Request for Substitutions: SMMH Imaging Suites

ITEM: CH-01

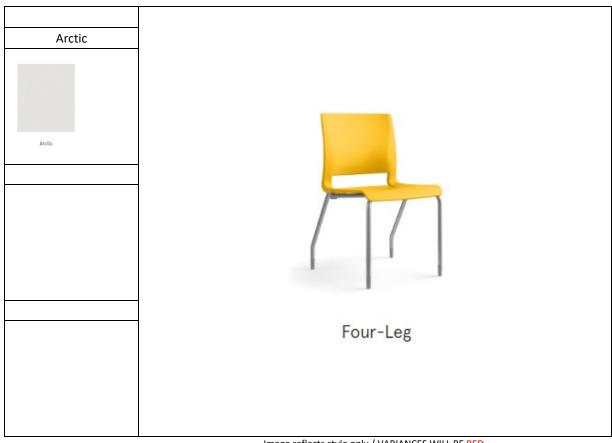
G70 APPROVED. NEED PHYSICAL SAMPLE OF

SEAT UPHOLSTRY IF

SELECTED.

ITEM: T-02

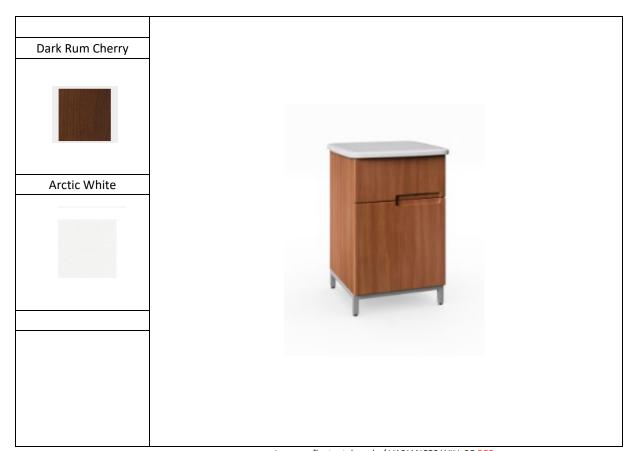
G70 APPROVED.
